Northern Cumberland Memorial Hospital

March 26, 1981

Our hospital is currently undergoing an expansion and renovation project by Hospital Building and Equipment Company of St. Louis, Missouri. There is some concern amongst our staff as to the conformance of the design of the new isotope storage area with applicable NRC Regulations.

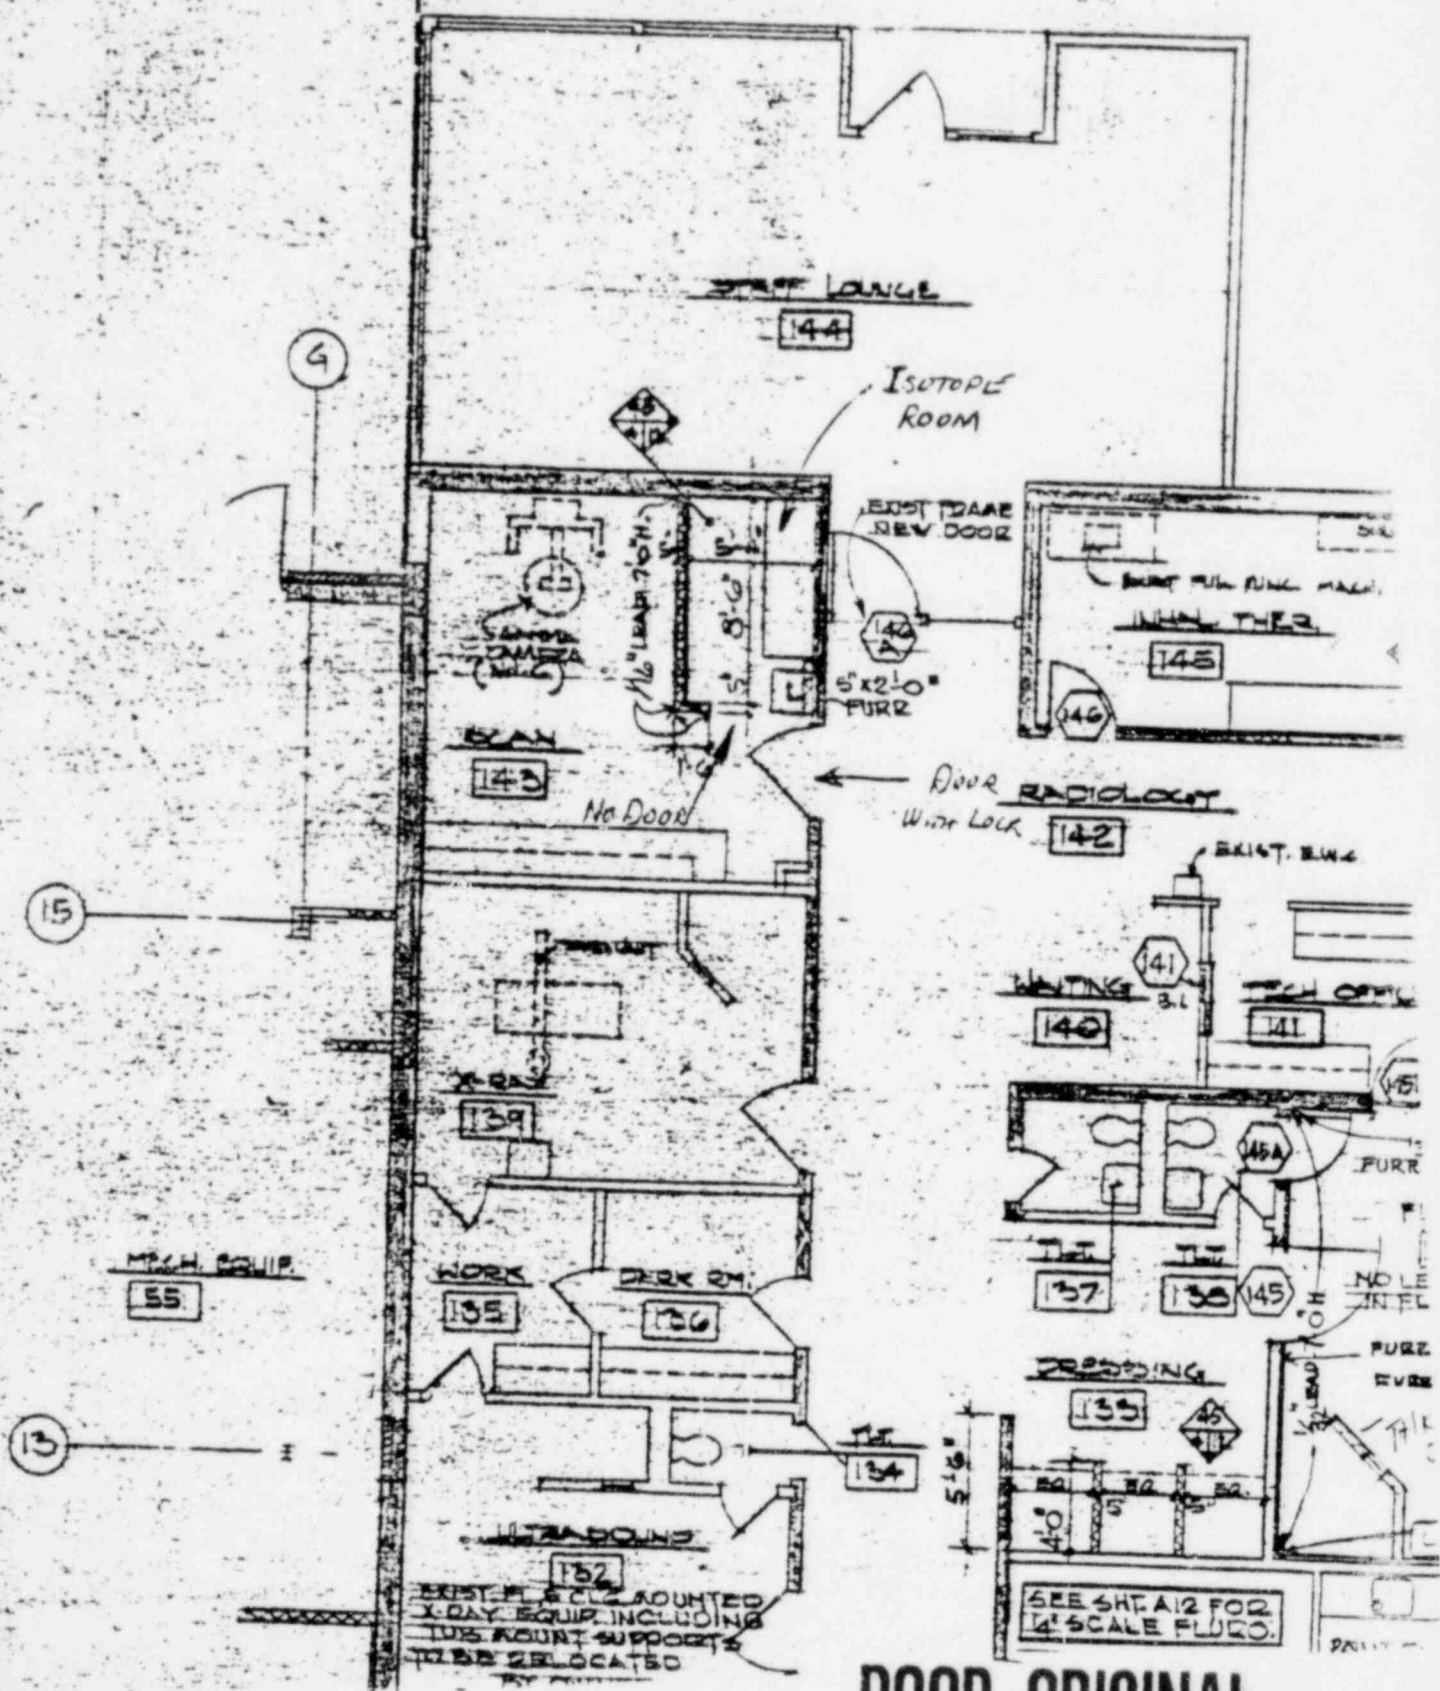
The attached sketch shows the design of the storage area within a room containing our Gamma Camera (Scans). It is the belief of some of our staff that the storage area should have a separate door with a lock in addition to the door to the Scan room which has a lock. During the design, the Architect contended that the presence of a lock on the door to the Scan room fulfilled the requirements of applicable regulations.

Please review the attached sketch and advise us whether the room as designed meets your requirements for accessibility. If it does not, please state the reasons so that we can forward them to our Architect and have appropriate changes made. Your expeditious consideration of this matter would be appreciated as we are already under construction. If you should have any questions please feel free to contact Mrs. Paula Morse or Mr. Dale Morse at (203) 647-8841, Ext. 244.
